Contract #: 04-0120F4Cty: SF/ALA Rte: 80 PM: 13.2/13.9File #: 69.25B**QUALITY ASSURANCE -- NON-CONFORMANCE REPORT****Location:** Changxing Island, Shanghai, PRC**Report No:** NCR-000244**Prime Contractor:** American Bridge/Fluor Enterprises, a JV**Date:** 07-Apr-2009**Submitting Contractor:** Zhenhua Port Machinery Company, Ltd (ZPMC), Changxing Island**NCR #:** ZPMC-0218**Type of problem:****Welding****Concrete****Other****Welding****Curing****Procedural****Bridge No:** 34-0006**Joint fit-up****Coating****Other****Component:** Deck Panels on 3AW, 3AE, 4BW**Procedural****Procedural****Description:****Reference Description:** Unapproved base metal welding and heat straightening**Description of Non-Conformance:**

Job Name: SAS Superstructure

Subject: NCR No. ZPMC-0218

Reference Description: Unapproved base metal welding and heat straightening

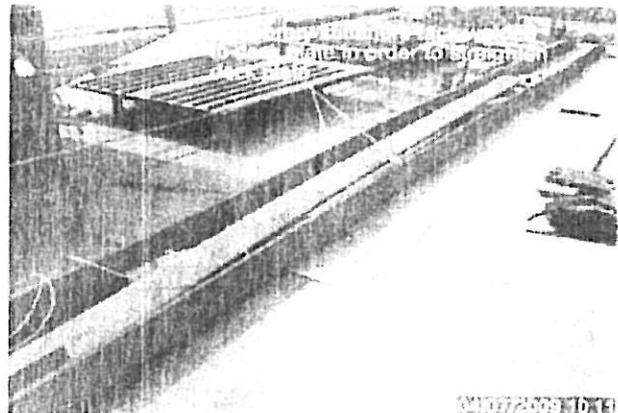
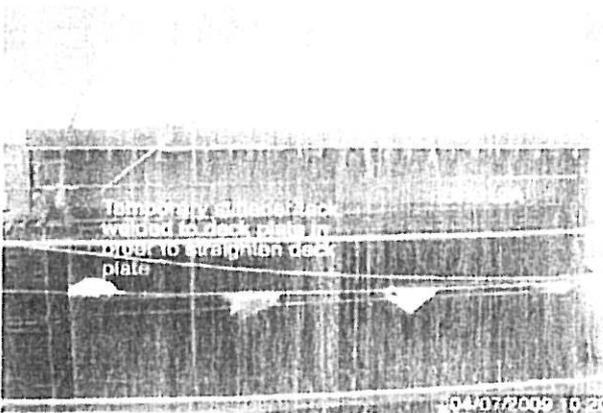
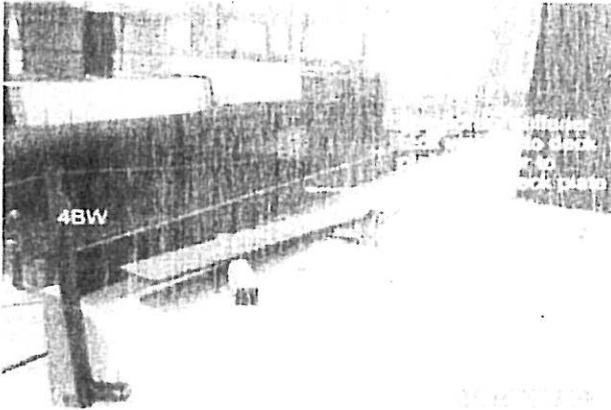
Quality Assurance Inspector observed that the Contractor welded temporary stiffener plates to deck panels DP011A (segment 3AW), DP012A (segment 3AE), and DP047A (segment 4BW) at the crossbeam locations. These stiffener plates and deck panels had heat straightened marks. The placement of these stiffener plates were not shown in the shop drawings and the fabrication procedures. The heat straightening operations were also not approved by the Engineer.

AWS D1.5 2002, Section 3.1.5 -- "Welds shall be prohibited on the work except as follows:

AWS D1.5 2002, Section 3.7.3 -- "Members distorted by welding shall be straightened by mechanical means or by carefully supervised application of a limited amount of localized heat as approved by the Engineer."

For the areas where the temporary welds were removed, please provide documentation of the weld repairs that were performed and that the areas have been accepted by MT. The Department will review the Contractor's proposal to close Non-Conformance ZPMC-0218 at that time.

HSR1(B)-5761

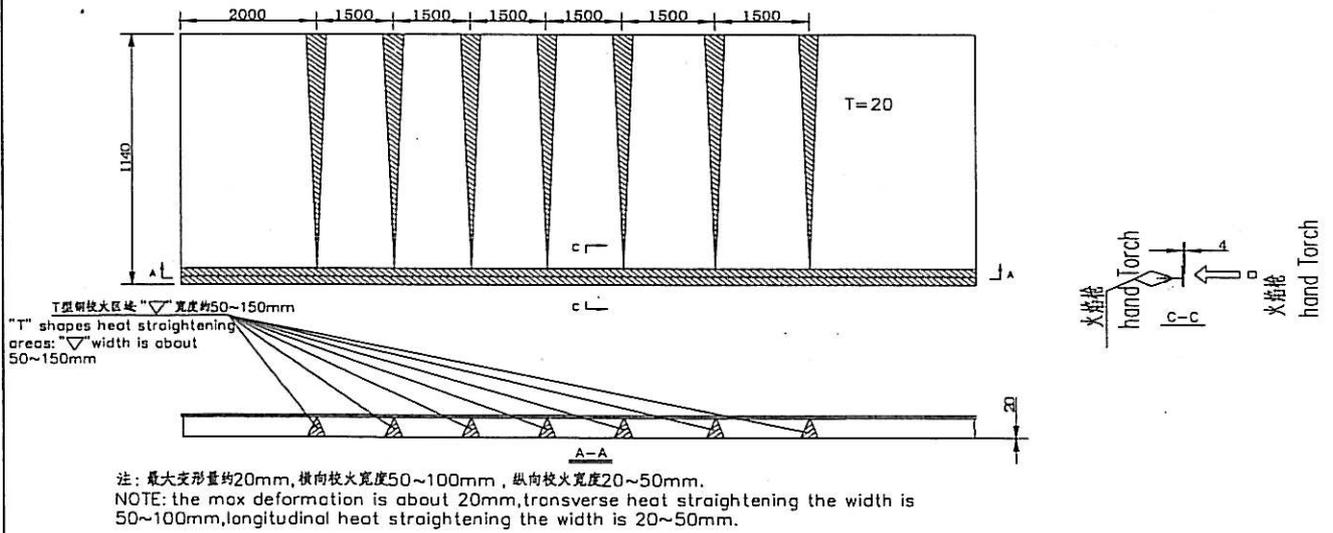
Cause原因 Welding distortion 焊接变形

Type of Defect缺陷类型 Welding distortion 焊接变形

缺陷去除方法(Defect Removal Method): Flame Straightening by oxygen acetylene

后续NDE(Post-Removal NDE): After finishing heat straightening, the weld of the heat area shall perform NDT according to the approved shop drawing

纠正措施(Corrective Action(s)): Control current, voltage and weld speed according to relevant WPS. If necessary anti-deformation or hold down device can be added.

最高温度(Maximum temperature): <650°C

HSR1(B)-6071

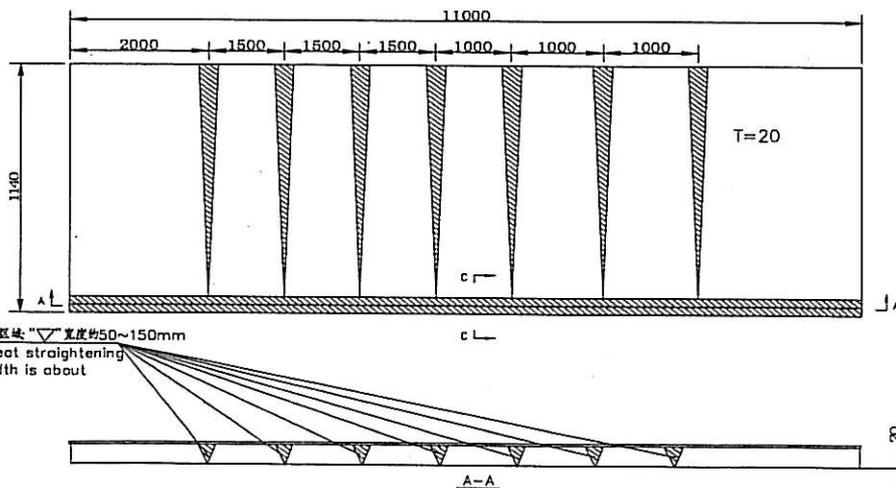
Cause 原因 Welding distortion 焊接变形

注: 最大变形量约20mm, 横向枝火宽度50~100mm, 纵向枝火宽度20~50mm.
 NOTE: the max deformation is about 20mm, transverse heat straightening the width is 50~100mm, longitudinal heat straightening the width is 20~50mm.

缺陷去除方法(Defect Removal Method): Flame Straightening by oxygen acetylene

After finishing heat straightening, the weld of the heat area shall perform NDT according to the approved shop drawing

Control current, voltage and weld speed according to relevant WPS. If necessary anti-deformation or hold down device can be added.

T型梁火工区域: "T" 宽度的50~150mm
 "T" shapes heat straightening areas: "T" width is about 50~150mm

HSR1(B)-5780

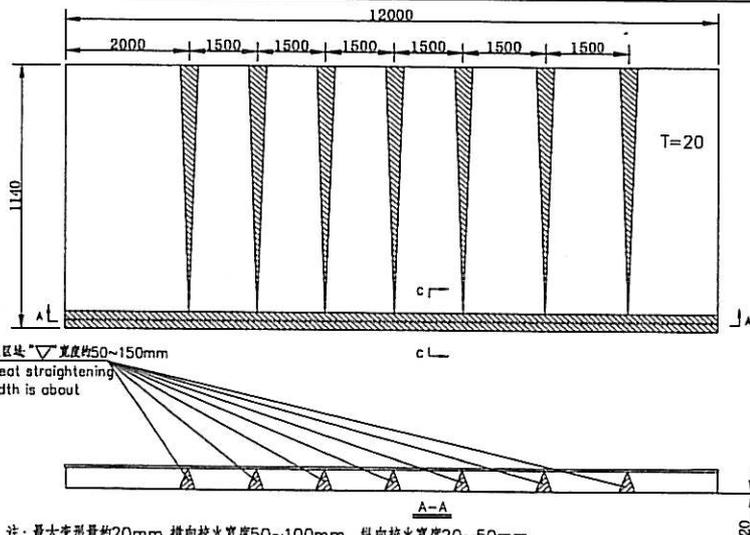
Cause 原因: Welding distortion 焊接变形
 Type of Defect 缺陷类型: Welding distortion 焊接变形
 Inspection Method 检查方法: Visual 目检

注: 最大变形量约20mm, 横向热火宽度50~100mm, 纵向热火宽度20~50mm.
 NOTE: the max deformation is about 20mm, transverse heat straightening the width is 50~100mm, longitudinal heat straightening the width is 20~50mm.

缺陷去除方法 (Defect Removal Method): Flame Straightening by oxygen acetylene

后续 NDE (Post-Removal NDE): After finishing heat straightening, the weld of the heat area shall perform NDT according to the approved shop drawing

纠正措施 (Corrective Action(s)): Control current, voltage and weld speed according to relevant WPS. If necessary anti-deformation or hold down device can be added.

T型钢热火区: "T" shapes heat straightening areas: "V" width is about 50~150mm

点焊移除的
WRR/CWR
NT 报告

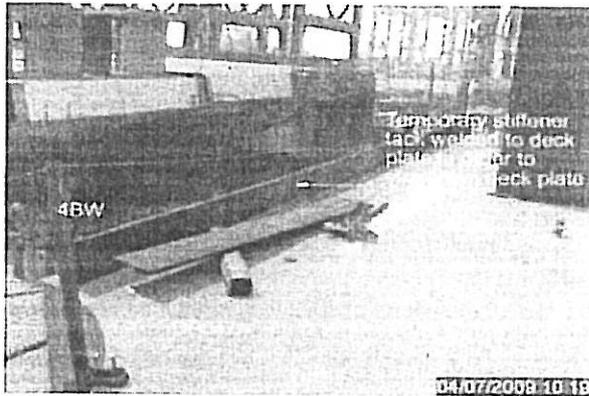
Quality Assurance Inspector observed that the Contractor welded temporary stiffener plates to deck panels DP011A (segment 3AW), DP012A (segment 3AE), and DP047A (segment 4BW) at the crossbeam locations. These stiffener plates and deck panels had heat straightened marks. The placement of these stiffener plates were not shown in the shop drawings and the fabrication procedures. The heat straightening operations were also not approved by the Engineer.

With this letter of response, ZPMC requests closure for Caltrans **NCR-000244 (ZPMC-0218)**. As the comments of the NPR "please provide the documentation of the weld repairs that were performed and that the repairs were acceptable", we have removed the temporary stiffener and repair the tack point, after confirm by ZPMC MT inspection we also notify the caltrans inspector to recheck by the MT method. we submit the corresponding MT reports to support the good quality and accepted by visual and NDT inspection of all parties.
